Re: 100 Industrial Park Road
Proposed Shipping Warehouse

We are in receipt of Vanasse & Associates, Inc.'s comments dated July 20, 2020, regarding the supplemental traffic engineering peer review for the project noted above. Vanasse & Associates' additional comments and shown in bold text, our responses are indicated in ***bold italic*** text and are as follows:

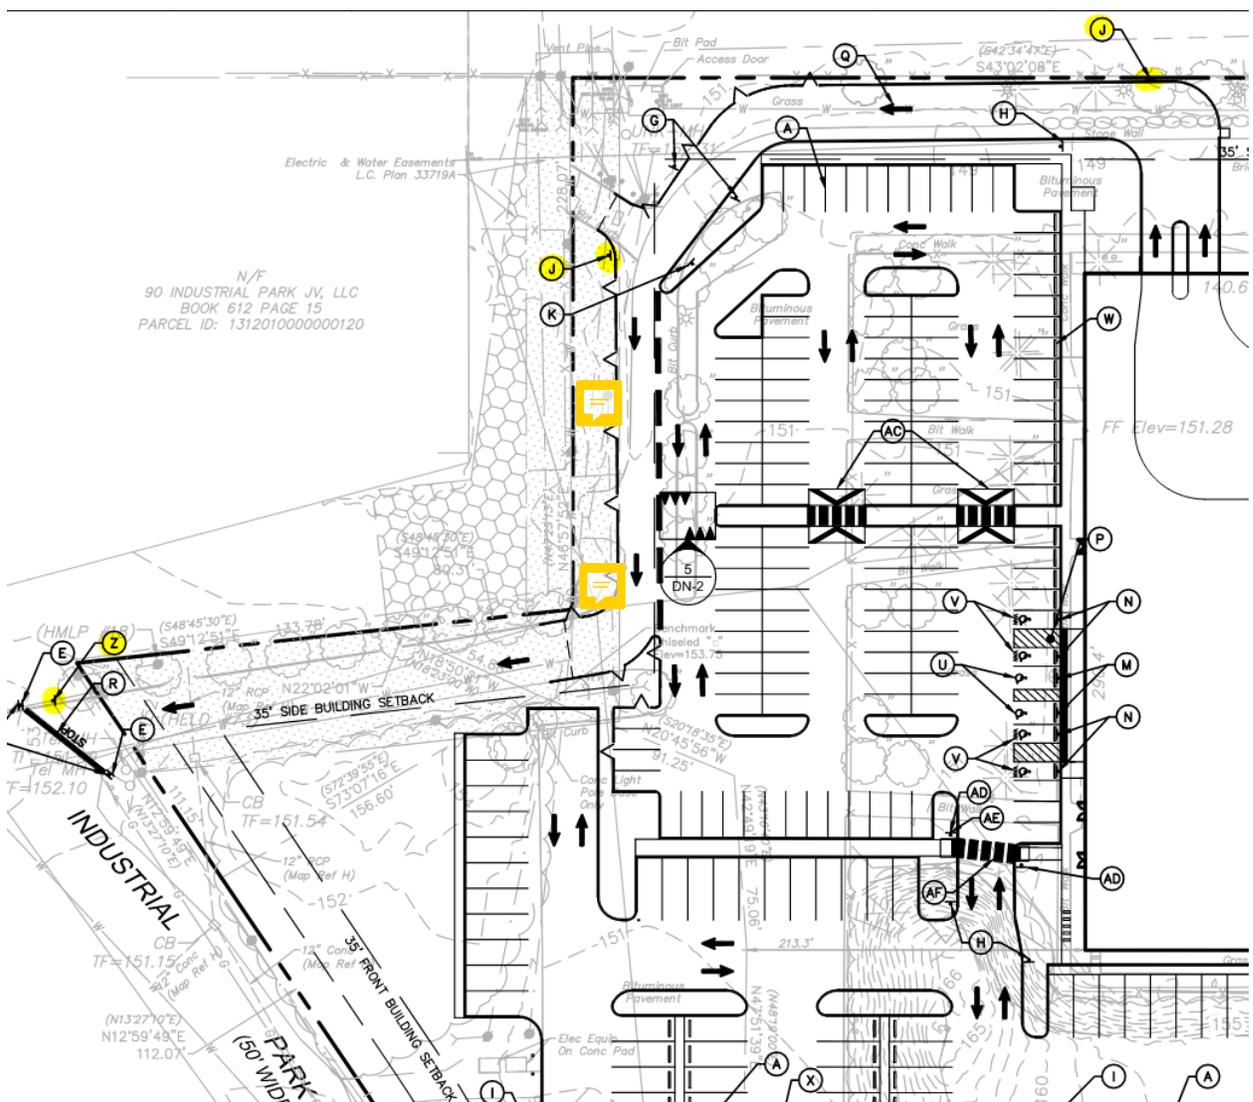
1. Comment S3: The requested signs and pavement markings have been added to the Site Plan. The following corrections should be made on the final Site Plans:
 - Sheet SP-3 should indicate “Install R3-2 Sign (No Left Turn) (Typ.)” (Keynote Legend “Z”) on Industrial Park Road opposite the Project site driveway as required by the Manual on Uniform Traffic Control Devices (MUTCD).1
 - Sheet SP-3 should indicate “Install S-1 Sign” (Keynote Legend “E”) on the Commerce Road approach to Industrial Park Road.
 - Sheet SP-3 should indicate “Install S-7 Sign” (Keynote Legend “J”) along the one-way exit to Industrial Park Road opposite the two (2) connections to the parking field.
 - Sheet SP-3 Keynote Legend “AB” should reflect a speed advisory of 20 mph as recommended in the June 2020 Traffic Study.

JD Response: Sheet SP-3 has been revised to add the requested signs and should be further revised as follows:

- **The R3-2 sign should be oriented toward (face) traffic exiting the Industrial Park**

Road Project site driveway.

- S-7 signs should be added at (2) locations along the north side of the one-way exit driveway facing vehicles exiting the parking field that is located to the north of the building as there are no signs in this area that indicate the one-way direction of the drive.

BL Response: Sheet SP-3 will be updated for the R3-2 sign and the S-7 sign as indicated below.

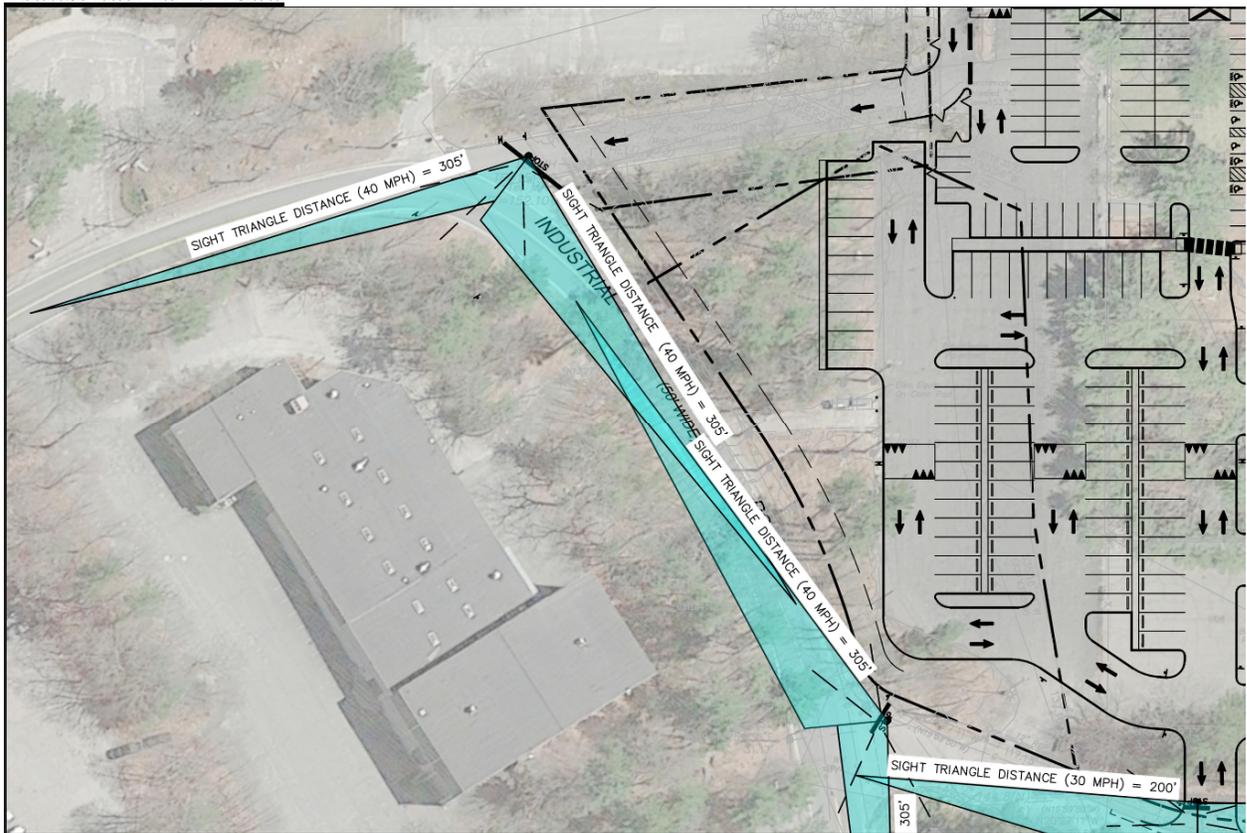
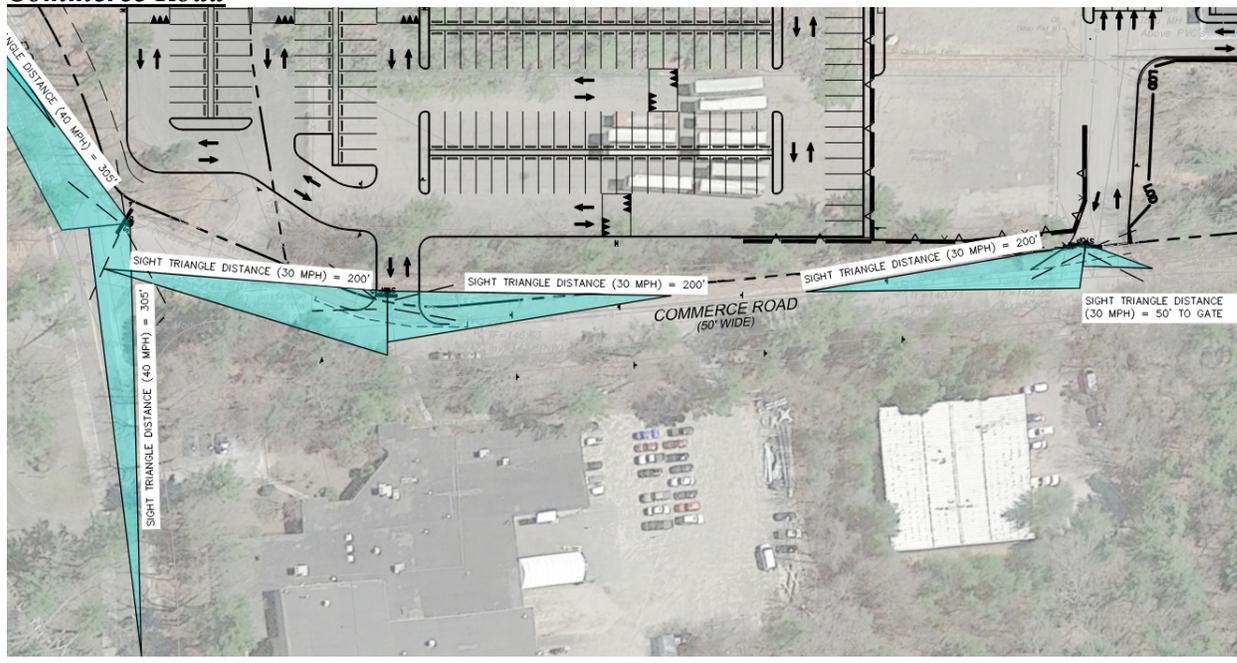
2. Comment S5: While the sight distances are helpful, the sight distance triangles were not shown. The sight distance triangles are based on the minimum recommended sight distances for the appropriate approach speeds approaching the driveways, or 305 feet for Industrial Park Road (40 mph) and 200 feet for Commerce Road (30 mph). We would recommend that a separate plan sheet be provided for the sight triangles and that the requested note be included on the plan sheet showing the sight triangles. An example sight triangle plan is attached for reference by the Applicant's engineer.

JD Response: As requested in our comment and shown on the example sight triangle plan that was provided to the Applicant's engineer, the sight triangles should be based

on the minimum recommended sight distances (305 feet for Industrial Park Road (40 mph) and 200 feet for Commerce Road (30 mph) and not the available sight distance. This will not impact the site layout or the design of the Project but should be corrected and the subject plan (Sheet No. SPD-1) should be added to the final Site Plans.

BL Response: Final SPD-1 site plan minimum sight distances will be updated to Sheet SPD-1 for final site plans as indicated with screen clip below.
